OOE Planning Committee (OOEPC)

Report to OOECA Board

(March 21, 2023 Meeting)

A2. TM Zoning: 2m Front Yard Setback - Allowable Uses

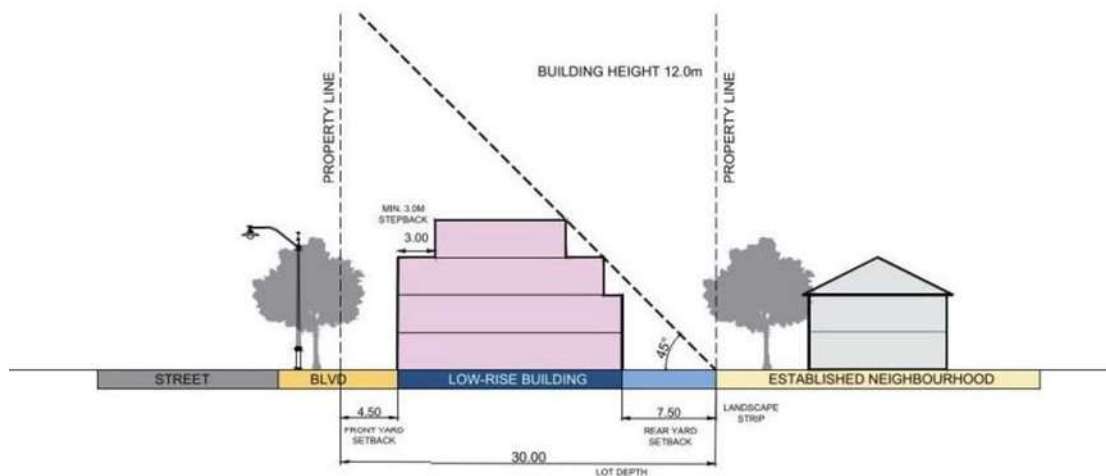
The unique TM zoning in Old Ottawa East requires that new developments have a two to three metre setback of the building from the front lot line. The recent proposal for 18 Hawthorne Avenue requests a 0.7 metre front yard setback and a reduced rear yard setback. Several recent Main Street proposals have also requested reduced rear yard setbacks. Also, we have seen applications proposing fixed installations (e.g., bicycle racks) within the 2 metre setback area and these should not be permitted.

As was negotiated with the City a decade ago when the OOE community design plan and subsequently the OOESP were approved, the front yard setback provision is meant to encourage pedestrians to "linger" and provides an opportunity for the commercial stores to place private signage, merchandise displays, other temporary appurtenances such as an outdoor seating areas. (Details to be attached for PRED meeting.)

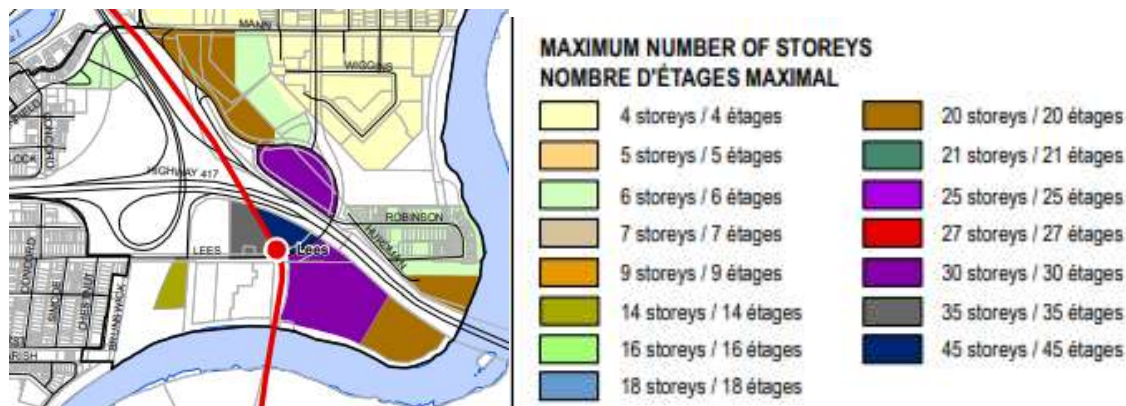
When Main Street was approved as a complete street, Council agreed that the reduced capacity of Main would not adversely affect the 1,000 unit target, however, the reduced capacity does mean that there is a reduced limit to what Main can handle and we have not yet seen this reality considered when application are reviewed by the City.

A similar situation may occur with Hawthorne Avenue which has a dwelling unit target of 150. The one development proposed so far (18 Hawthorne) would have 67 units (45 percent of the target) yet this building occupies only 17 percent of the "developable" Hawthorne frontage. This overdevelopment was not what was envisaged by the OOE SP.
